# RECORD OF MEETING

**Client:** City of Taunton **Date:** 05/17/19  
**Meeting Date:** 05/17/19 **Prepared By:** Mike Andrus  
**Meeting Location:** Taunton DPW **Job Number:**  
**Meeting Topic:** Industrial Park Drainage

This meeting was a follow up to a previous meeting and a site walkthrough to determine what repairs, etc. the City wishes to have completed by the TDC prior to the City taking possession and responsibility for the drainage system within the Myles Standish Industrial Park. Requested work has been shown, where available, on attached plans in red.

**BASIN #1  
1" = 40'**

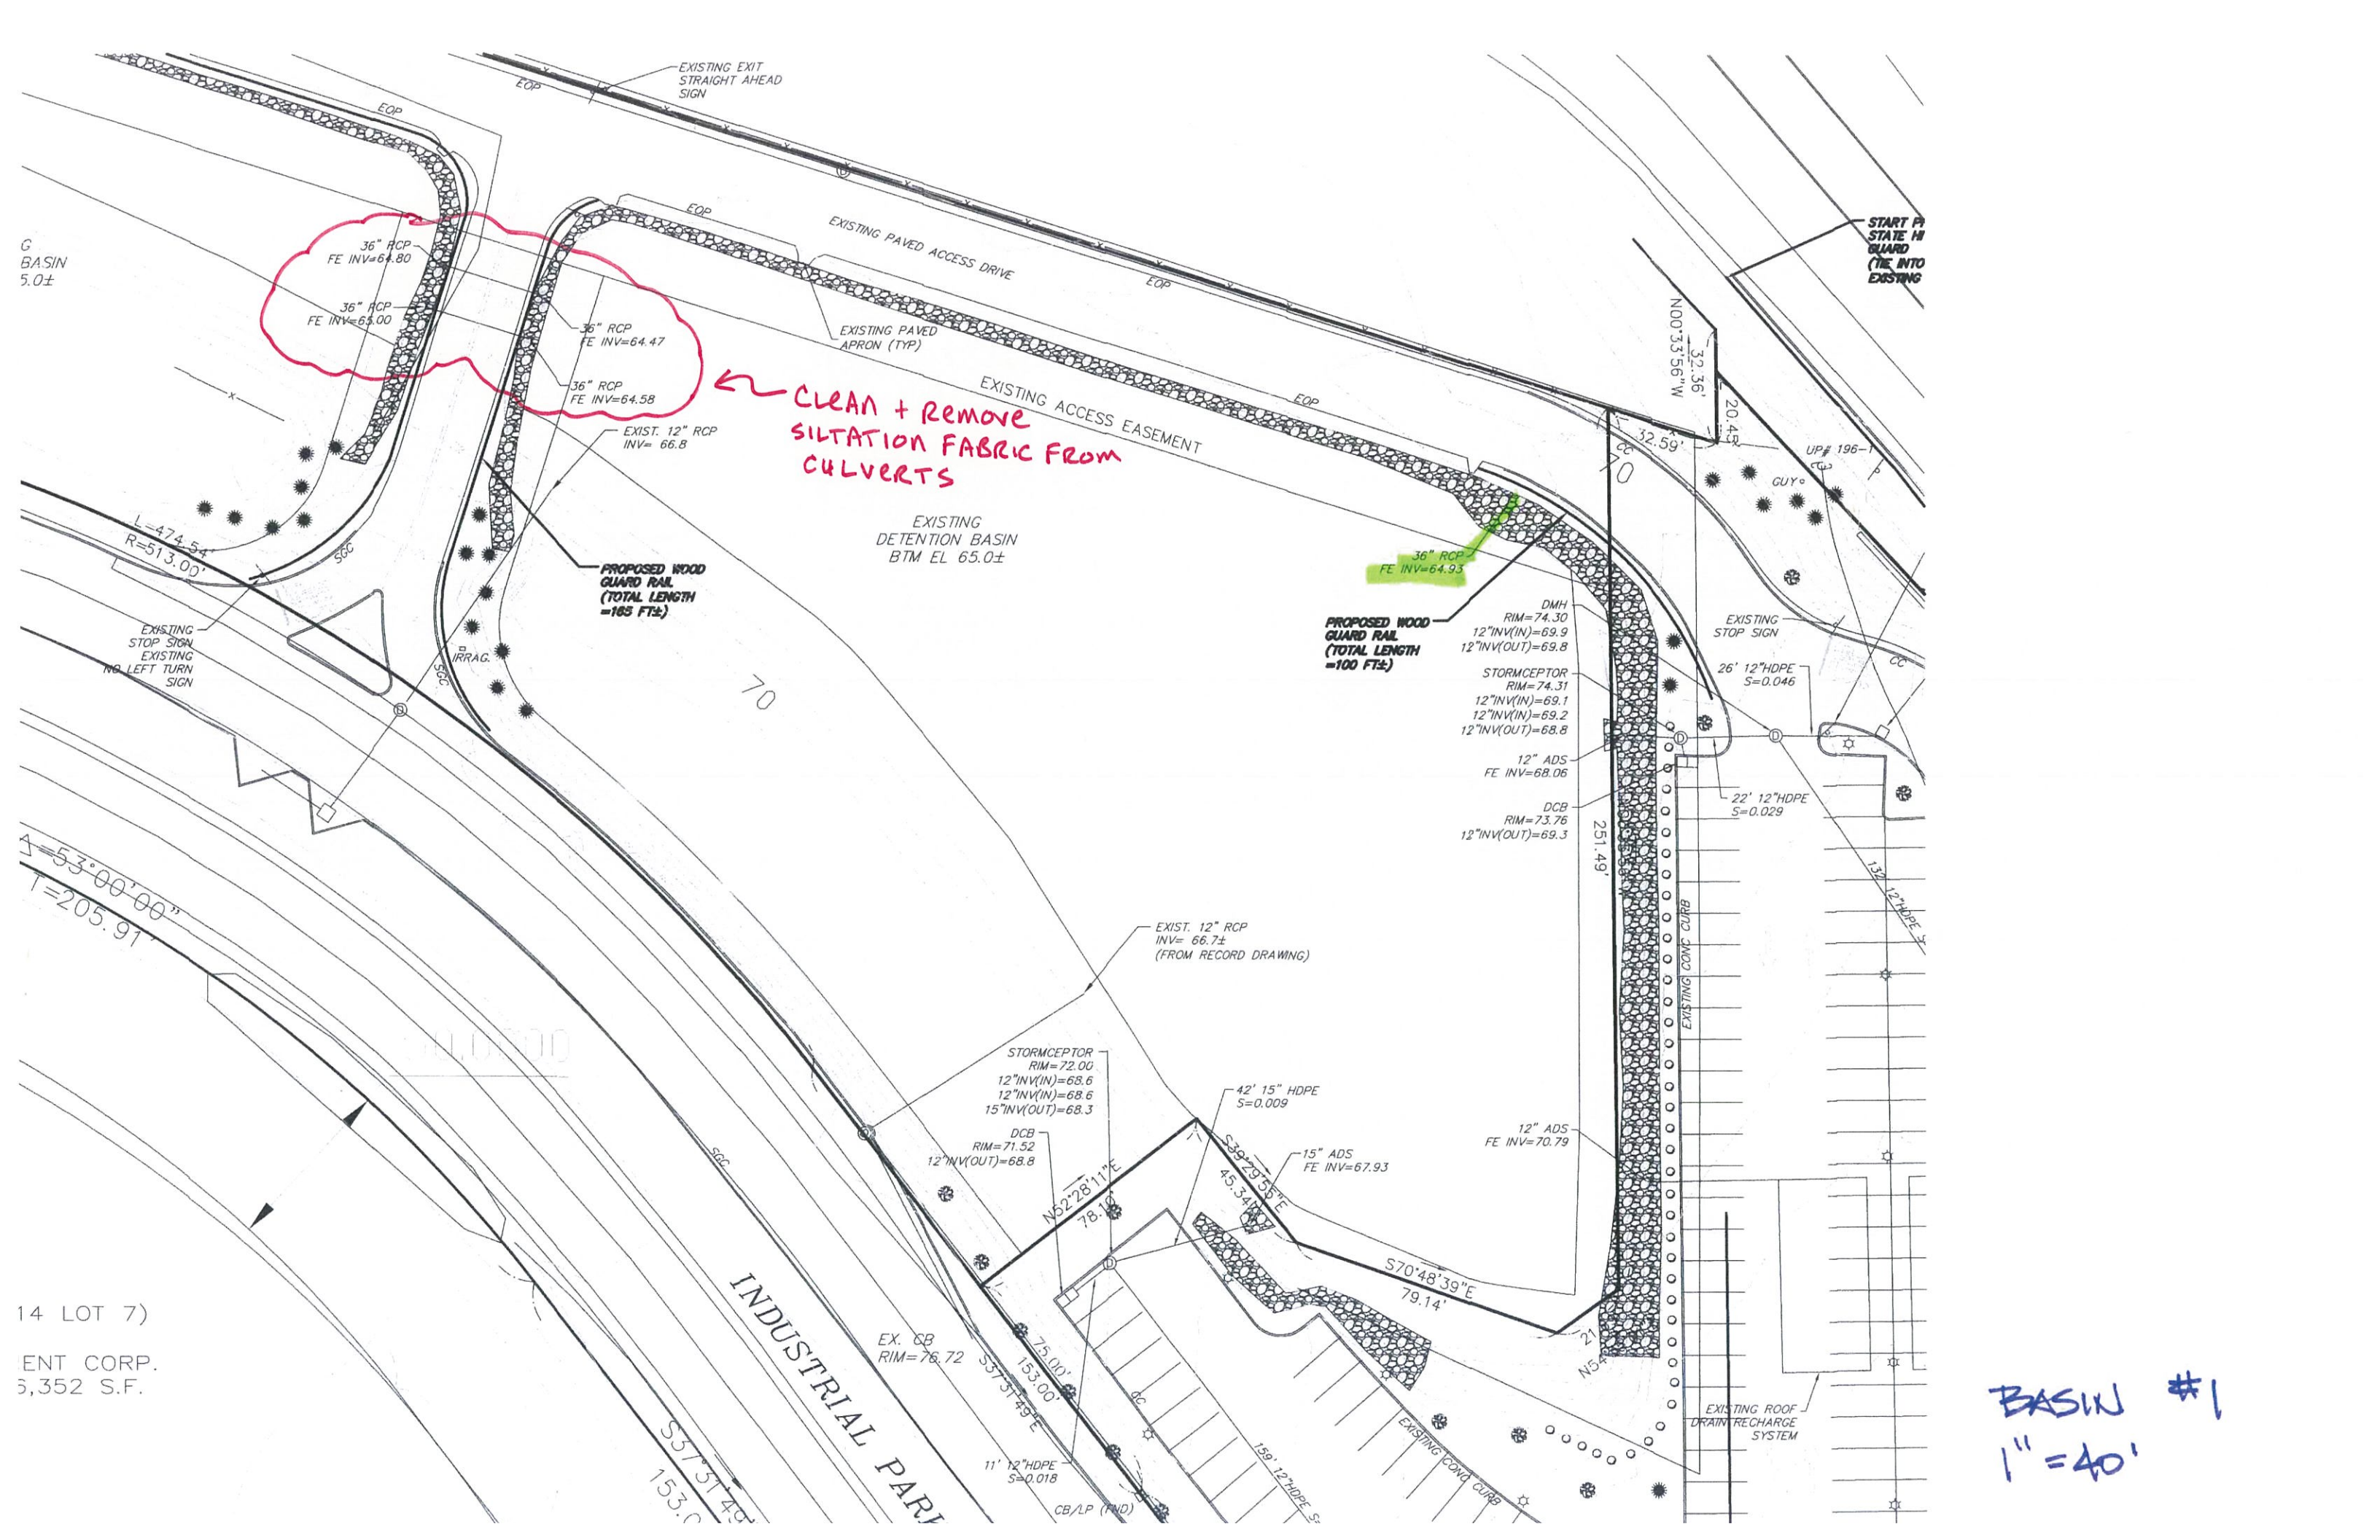
- I. Basin #1 (off Myles Standish Blvd)
  - A. Clean out (esp. siltation fabric) culverts connecting two halves of the basin
- II. Basin #2 (off Constitution Dr)

**CLEAN + REMOVE  
SILTATION FABRIC FROM  
CULVERTS**

BASIN #2  
1" = 80'

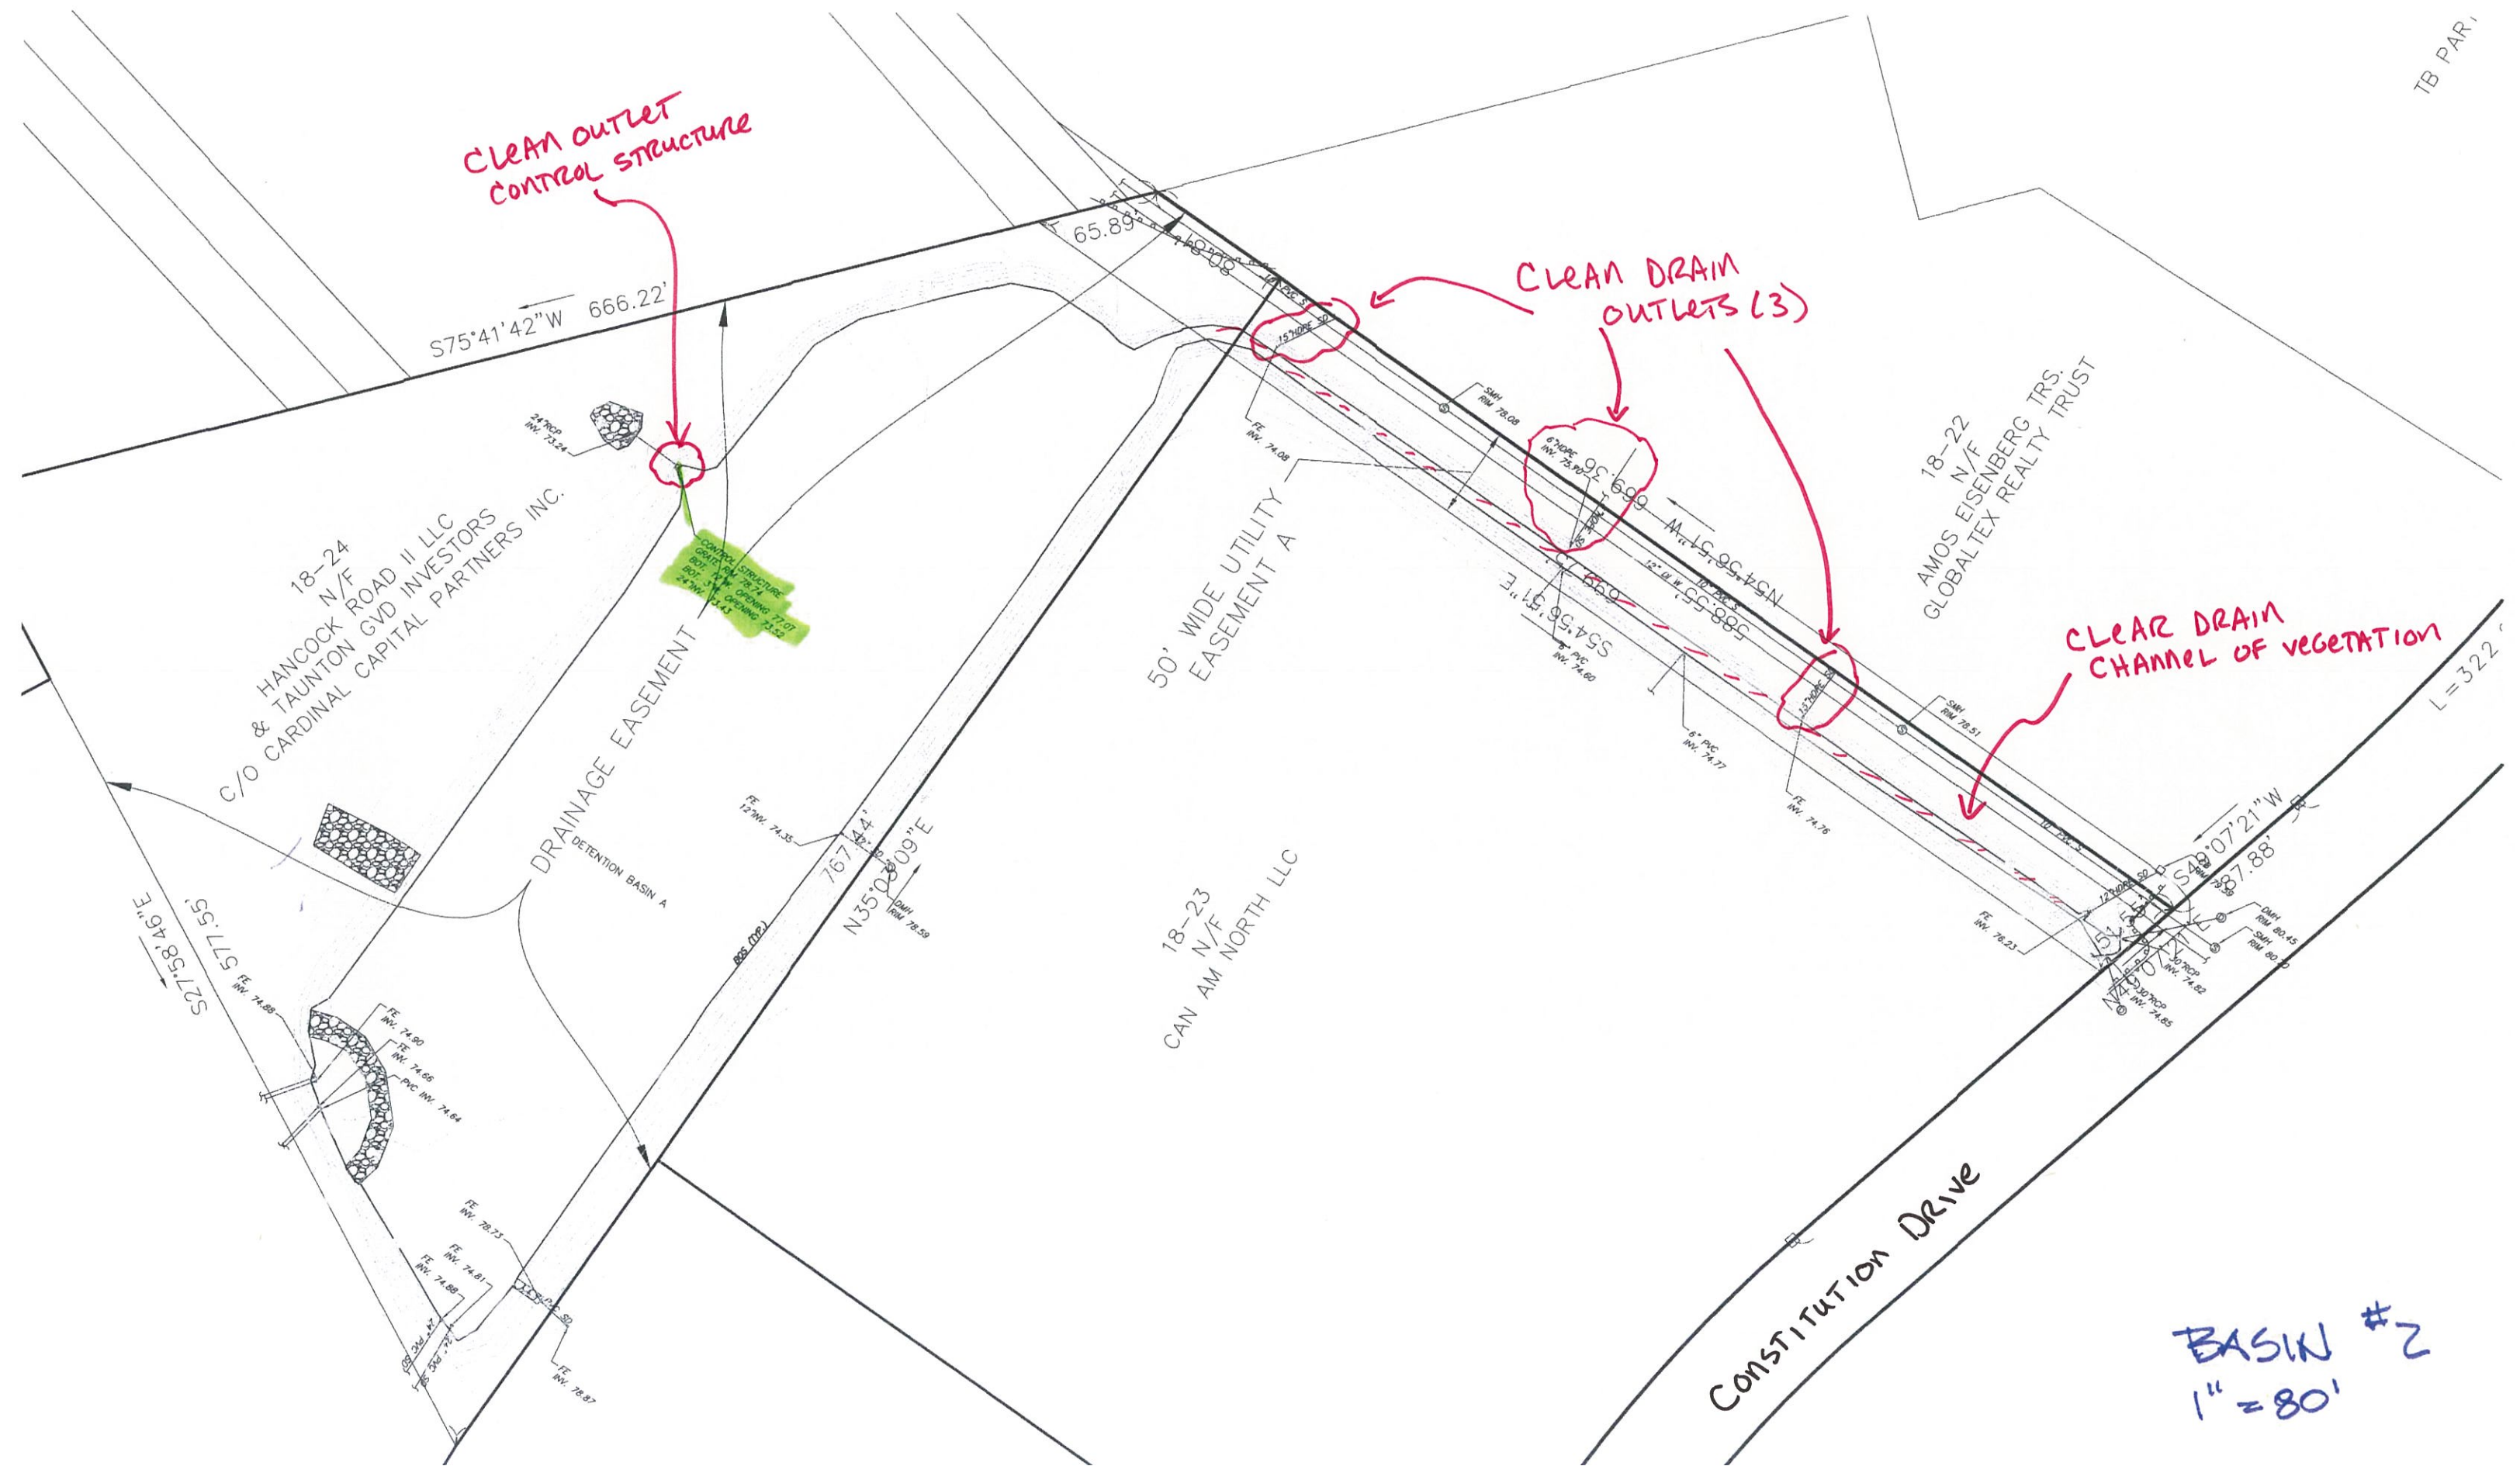
- A. Channel between Constitution Drive and Basin #2 needs to be rid of vegetation
  - B. Clean drain outlets from Eisenberg property
  - C. Outlet control structure needs to be cleaned out (rack plugs with debris)

CLEAN OUTLET  
CONTROL STRUCTURE

CLEAN DRAIN  
OUTLETS (3)

CLEAR DRAIN  
CHANNEL OF VEGETATION

BASIN #3  
1" = 100'

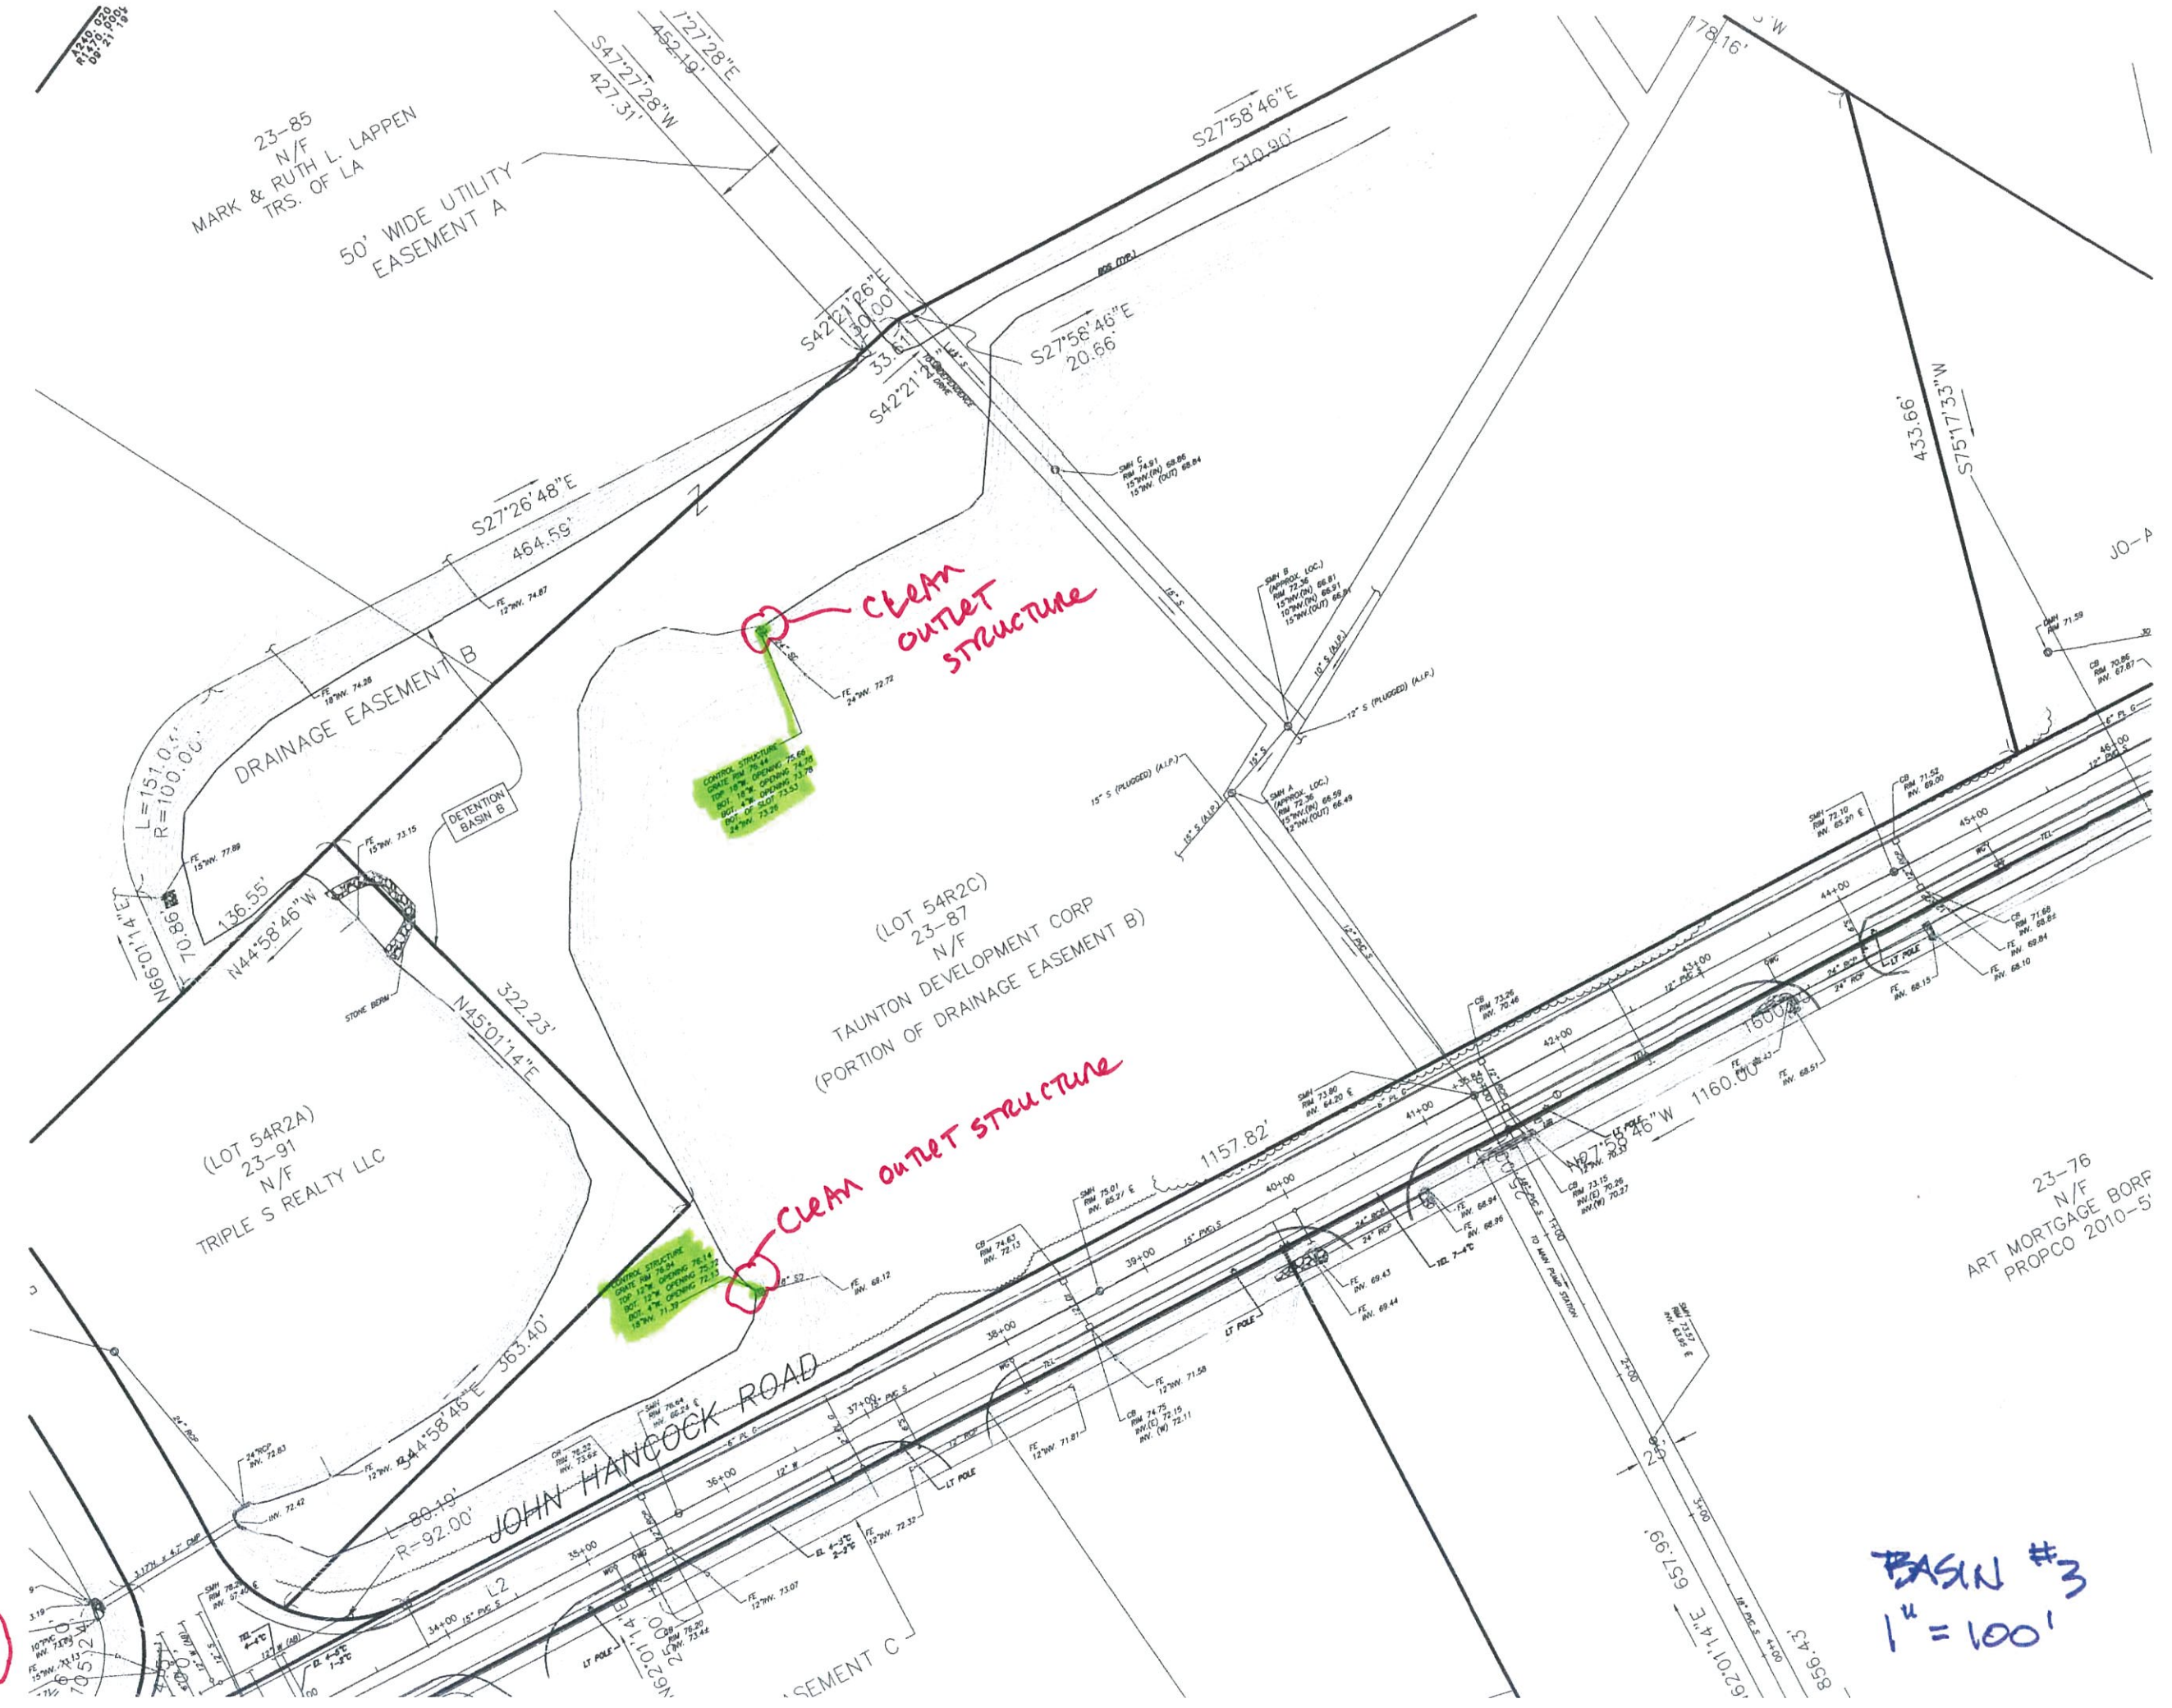
- III. Basin #3 (John Hancock Rd)
  - A. Channel leading into Basin #3 is choked with vegetation and needs clearing
  - B. Both outlet structures are clogged with debris and need cleaning

CLEAR VEGETATION  
FROM CHANNEL  
UPSTREAM  
OF BASIN #3

CLEAN  
OUTLET  
STRUCTURE

CLEAN  
OUTLET  
STRUCTURE
